## 2.15 Structures and Servicing Systems

The information in this section of the reference ABWR DCD, including all subsections, tables, and figures, is incorporated by reference with the following departures.

Table 2.15.5c Reactor Building Safety-Related Equipment HVAC System

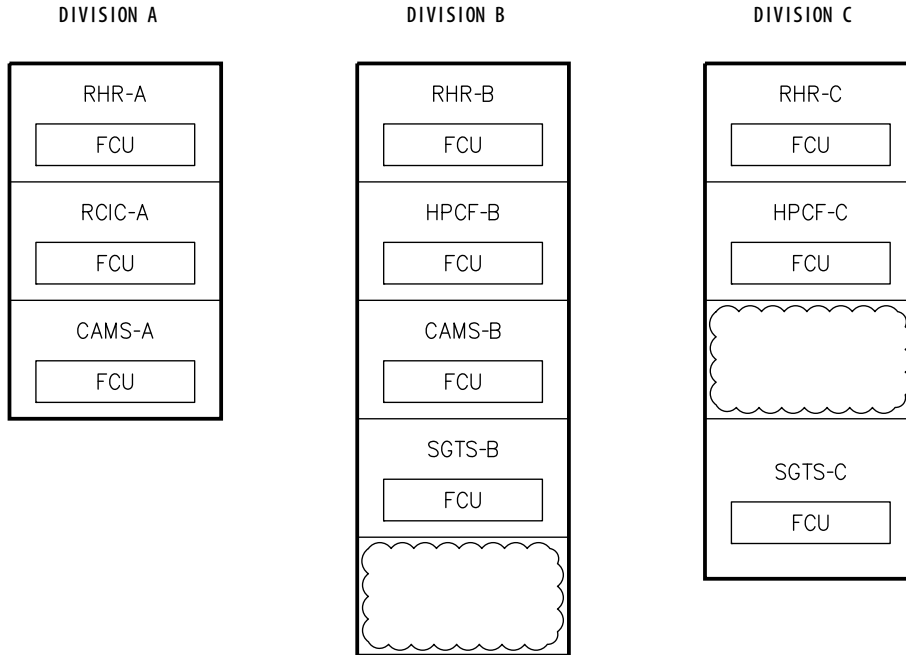
Inspections, Tests, Analyses and Acceptance Criteria		
Design Commitment	Inspections, Tests, Analyses	Acceptance Criteria
<del>4. The FGS room FCUs are initiated upon a manual FGS start signal. Not used.</del>	<del>4. Tests will be conducted on each as built FGS room FCU using a simulated initiation signal. Not used.</del>	<del>4. The FGS room FCU starts upon receipt of a signal indicating FGS start. Not used.</del>

**Figure 2.15.5e Reactor Building Safety-Related Equipment HVAC System**

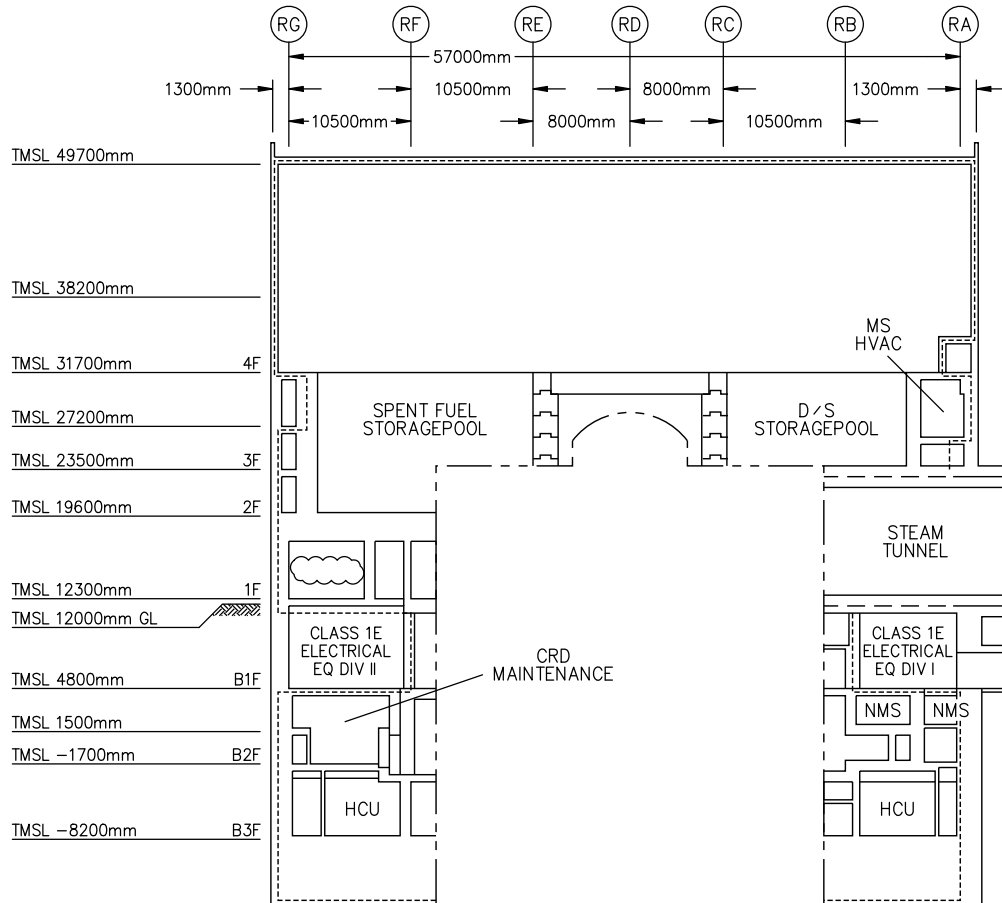
STD DEP T1 2.14-1 (Figure 2.15.10a, Figure 2.15.10j, Figure 2.15.5e, Table 2.15.5c)

*The R/B Safety-Related Equipment HVAC System provides cooling of safety-related equipment areas, and consists of independent fan coil units. Figure 2.15.5e shows the basic system configuration and scope.*

*The Residual Heat Removal (RHR) System, High Pressure Core Flooder (HPCF) System and Reactor Core Isolation Cooling (RCIC) System pump room FCUs are automatically initiated upon startup of their respective room process pump. The Containment Atmospheric Monitoring System (CAMS) and Standby Gas Treatment System (SGTS) room FCUs are automatically initiated upon isolation of the Reactor Building Secondary Containment HVAC System. ~~The Flammability Control System (FCS) room FCUs are also initiated upon a manual FCS start signal.~~*

Figure 2.15.12a Control Building Arrangement, Section A-A

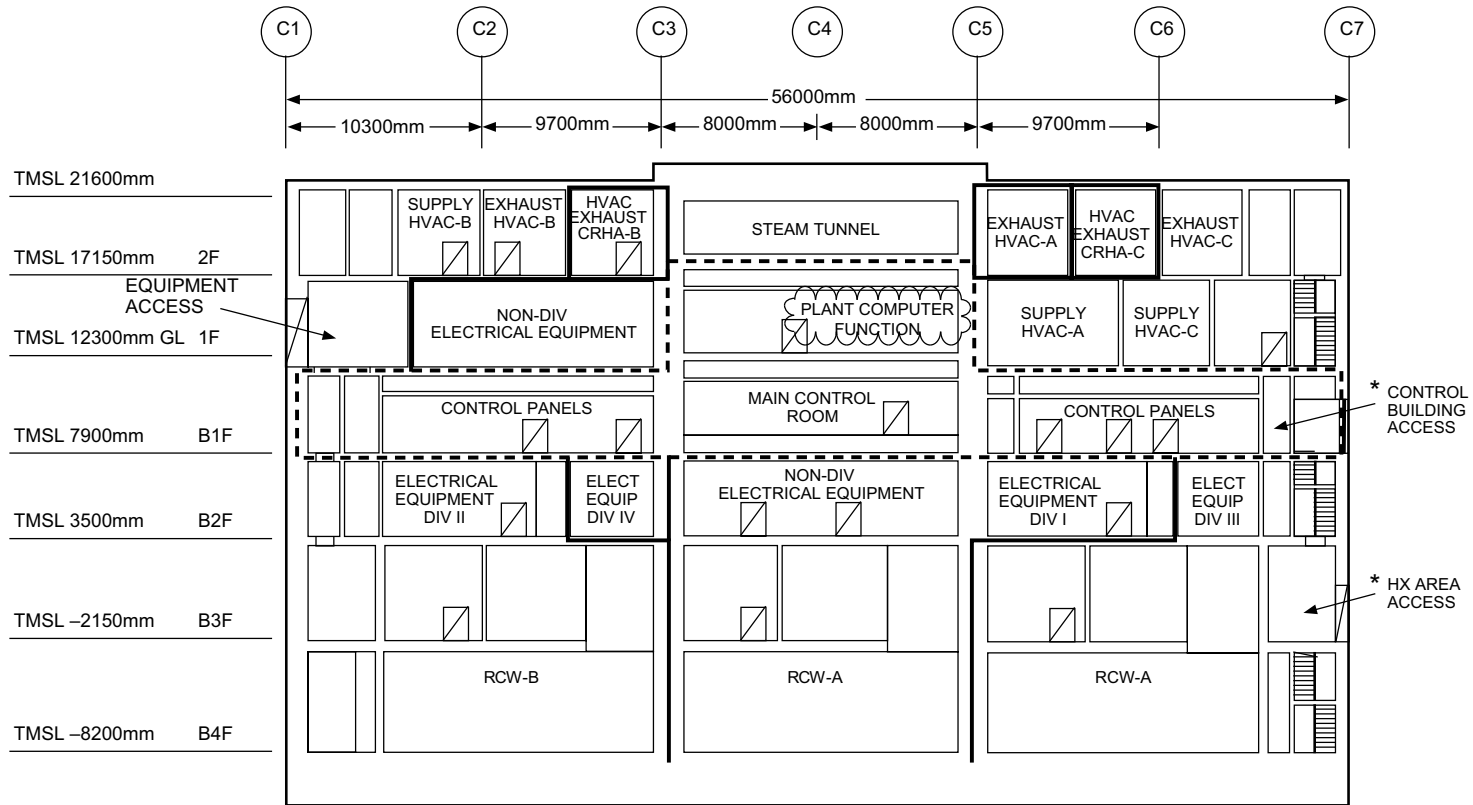
[STD DEP T1 3.4-1 \(Figure 2.15.12a, Figure 2.15.12b, Figure 2.15.12g\)](#)
